Appl. No. 10/642,313
Reply to Office action of December 17, 2004

Remarks

**FIG. 5****FIG. 6**

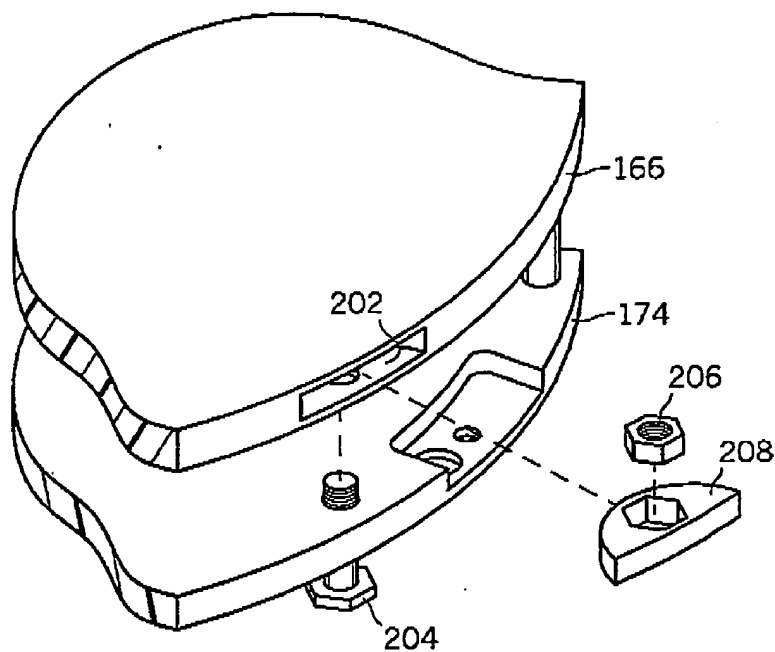
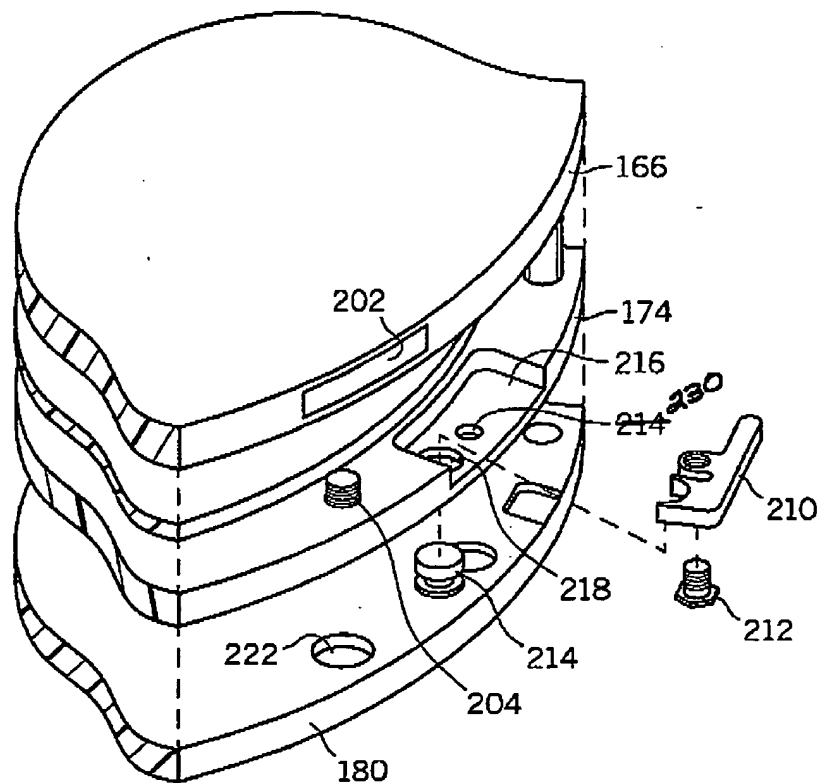
The drawings were objected to for using the same reference numeral to refer to two different elements. FIG. 8 has been amended to assign the number 230 to one of those elements. In reviewing the application, Applicants' attorney noticed that FIG. 6 suffered from the same type of error. Accordingly, FIG. 6 has been amended to apply the reference number 197 to the hollow portion of the light pin. FIG. 2 has also been amended to assign the reference
